WALDEN PRESERVE 2 - FILING NO. 1
FINAL DRAINAGE REPORT – ADDENDUM NO. 1
August 10, 2019

This Final Drainage Report Addendum has been prepared in response to El Paso County's request to upgrade the outlet structure of Walden Preserve Pond B to current full-spectrum detention design standards.

POND B - OUTLET STRUCTURE UPGRADE DETAILS

TRASH RACK & ORIFICE PLATE DETAIL C
(BASED ON UDFCD VOL. 3 FIGURE OS-6)

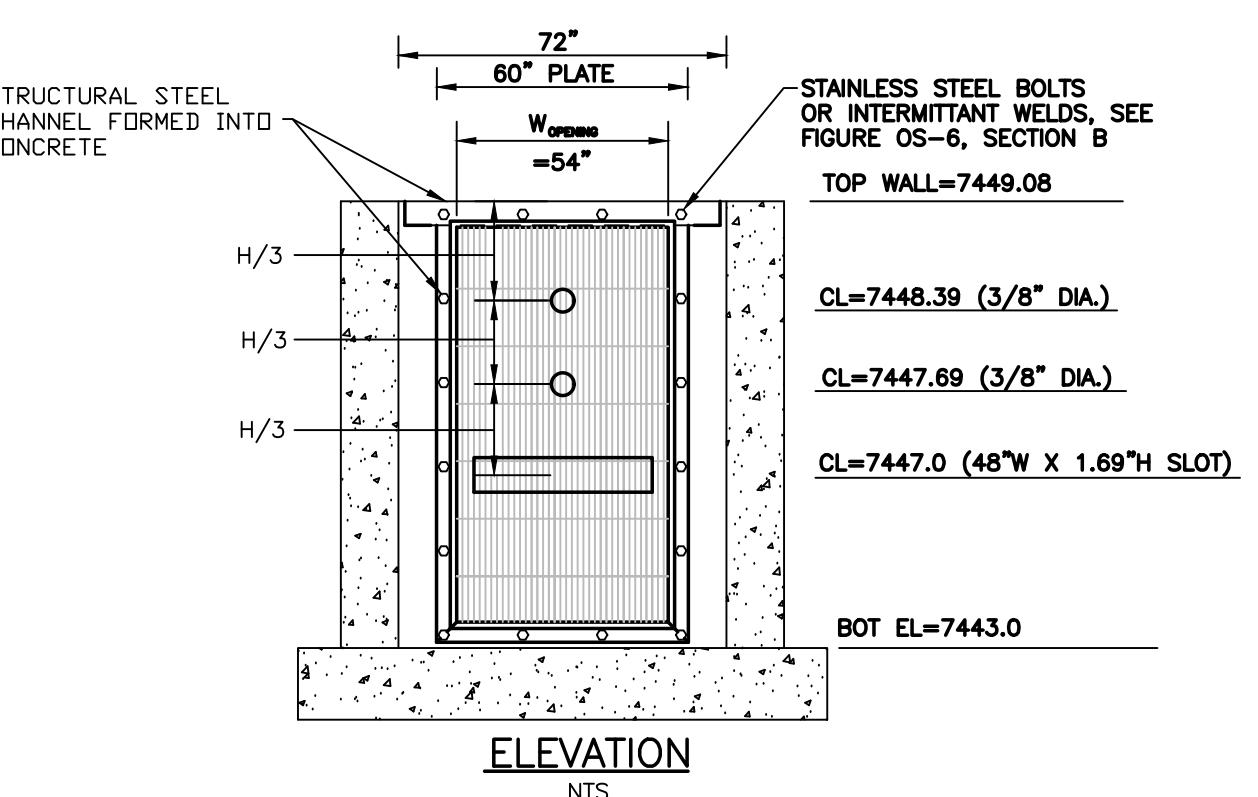
- ORIFICE PLATE NOTES:
1. PROVIDE CONTINUOUS NEOPRENE GASKET MATERIAL BETWEEN THE ORIFICE PLATE AND CONCRETE.
 2. BOLT PLATE TO CONCRETE 12" MAX. ON CENTER. SEE TABLE OS-2 FOR PLATE THICKNESS.

DETENTION POND B OUTLET STRUCTURE A

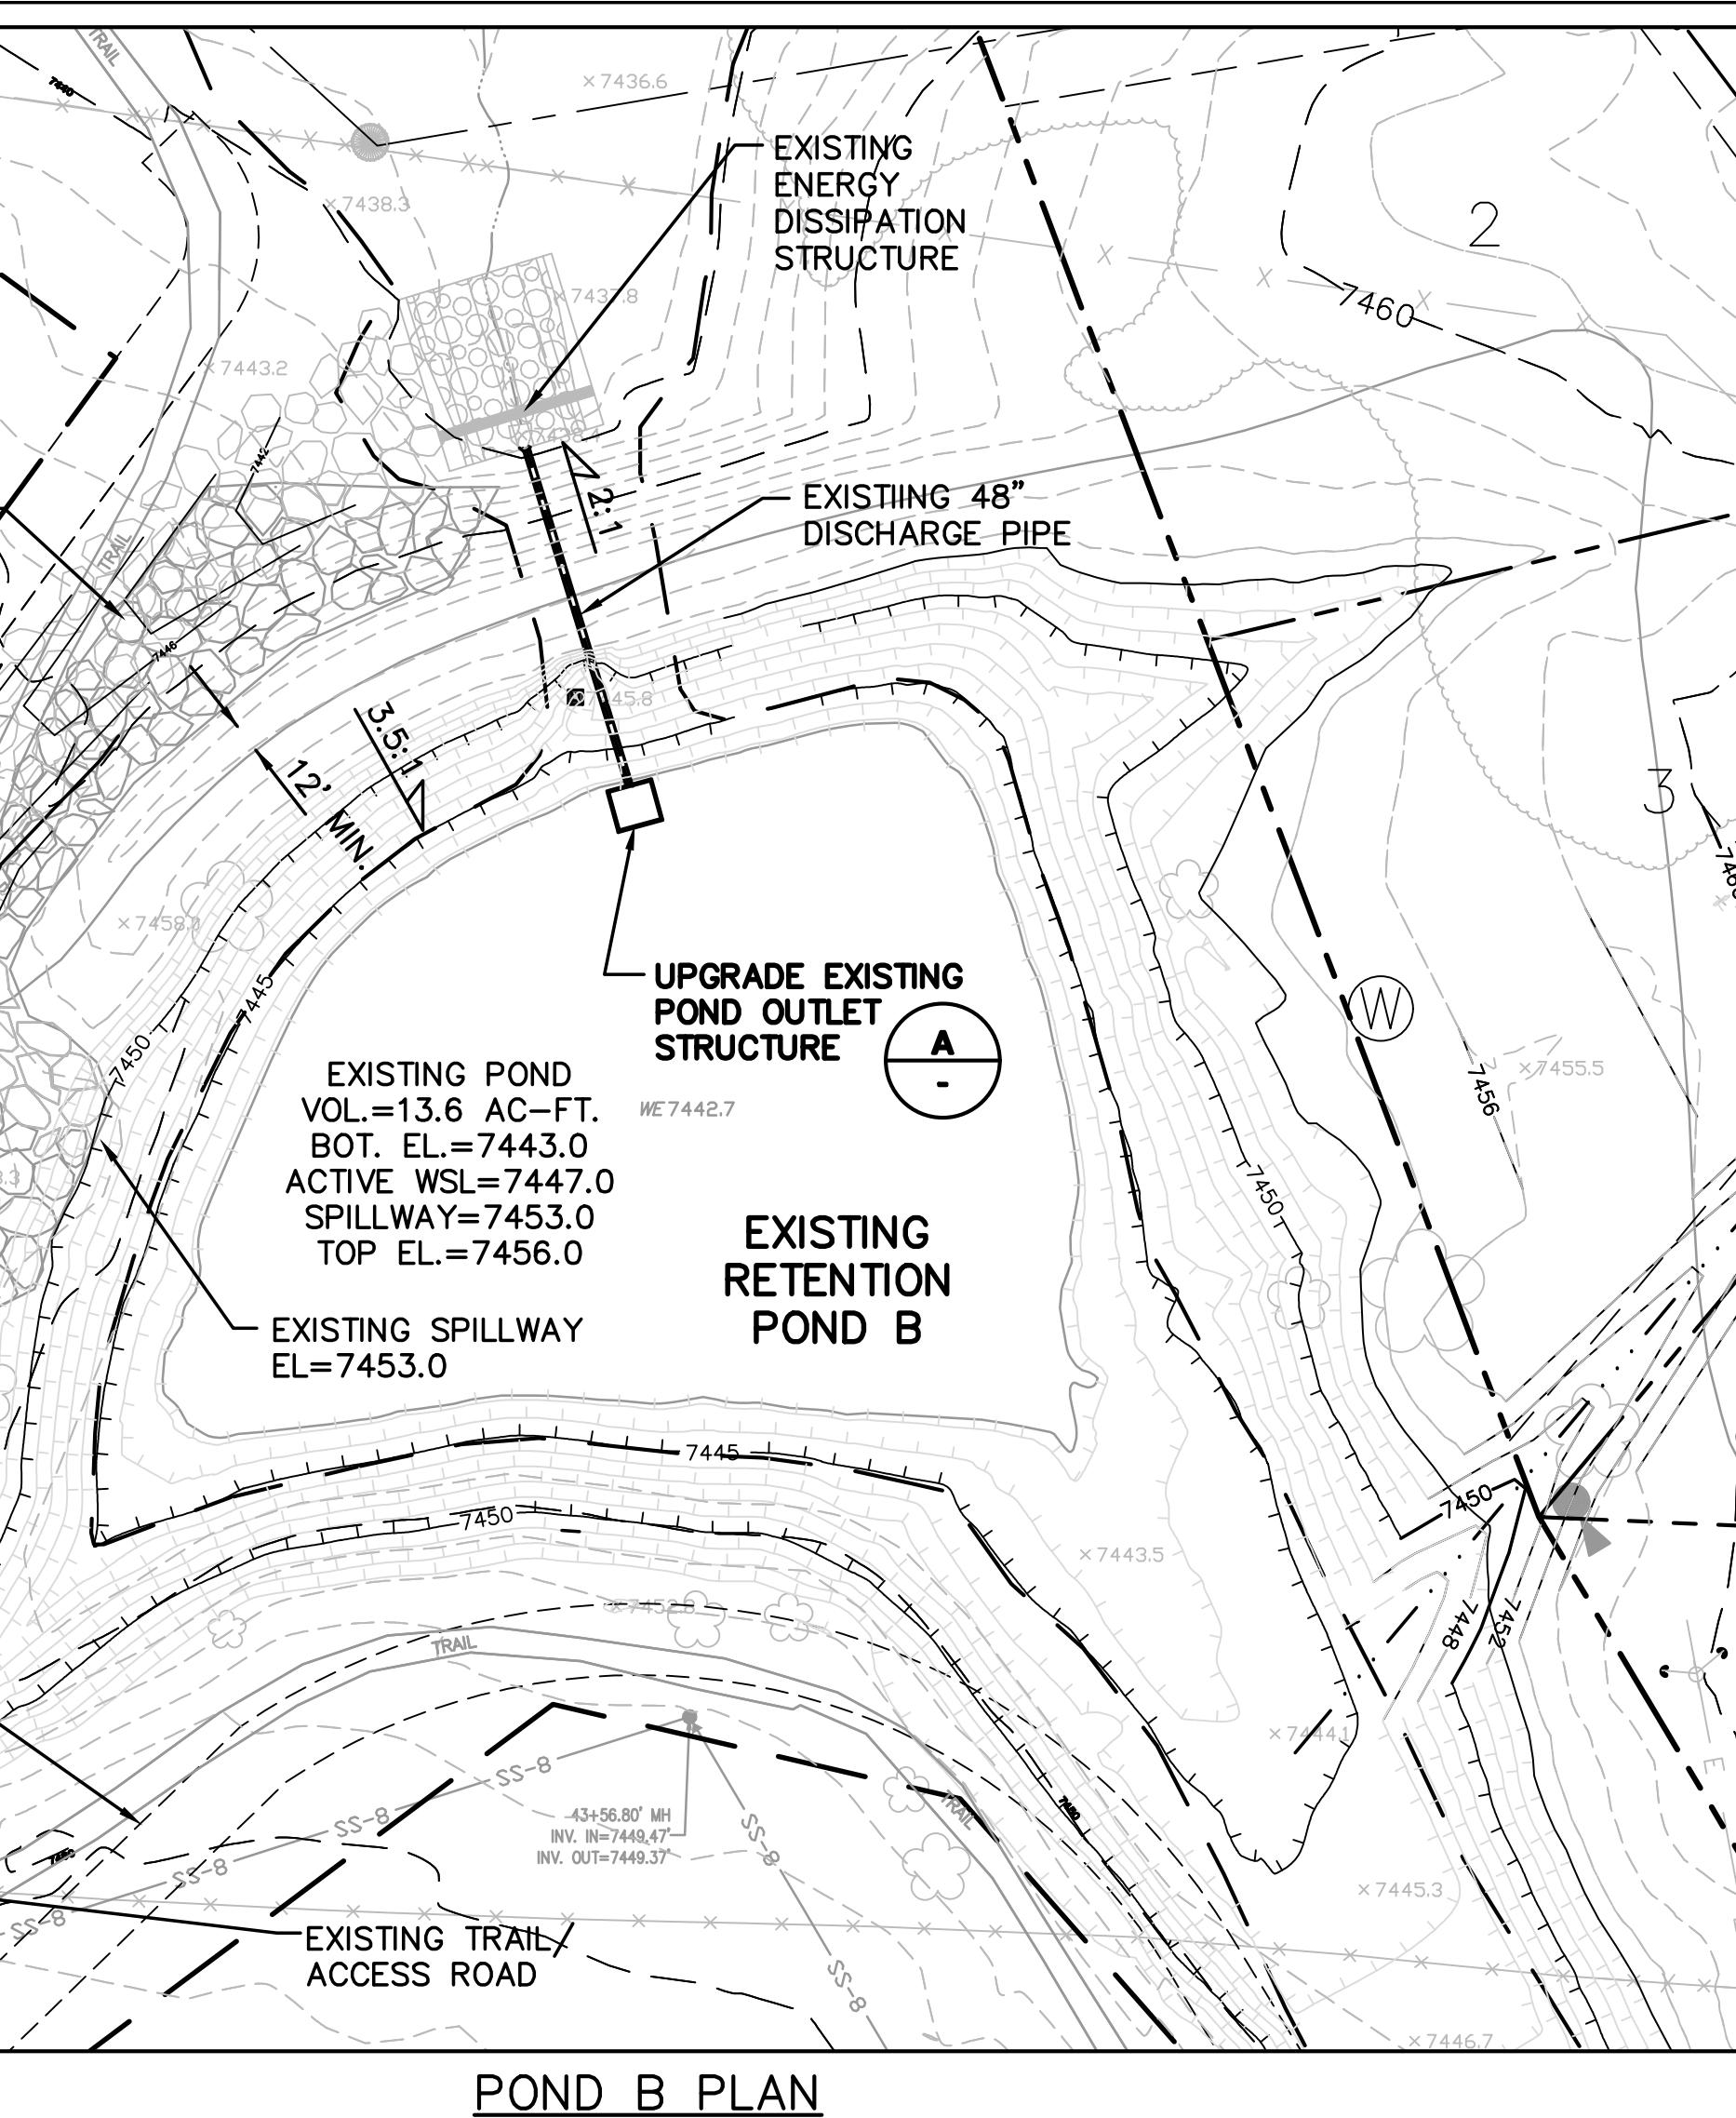
Based on the enclosed detention calculations, we recommend upgrading the existing pond outlet structure to current full-spectrum design standards by closing the west orifice, installing a new trash rack at the south face of the box and constructing a new interior wall and chamber within the outlet structure, providing a trash screen and orifice plate to meter flows through the structure. The proposed internal orifice plate will have a lower slot opening and two higher orifice openings sized based on the UD-Detention model. Additionally, a steel restrictor plate will be installed on the inside face of the box at the 48” discharge pipe opening.

EXISTING GRATE EL.=7451.0
TOP OF NEW INTERIOR WALL=7449.08
NEW SAFETY GRATE OVER EXISTING OPENING
EXISTING 36"x36" ORIFICE, INV.=7447.0
EXISTING 16"x16" ORIFICE, INV.=7445.7

FILL/PLUG EXISTING LOWER ORIFICE ON WEST WALL WITH CONCRETE
48" INV. OUT=7443.0
NEW 12" INTERIOR CONCRETE WALL (W/ #4 BARS @ 12"O.C.E.W.)

NEW BAR GRATE TRASH RACK
SECTION
NEW WQCV ORIFICE PLATE
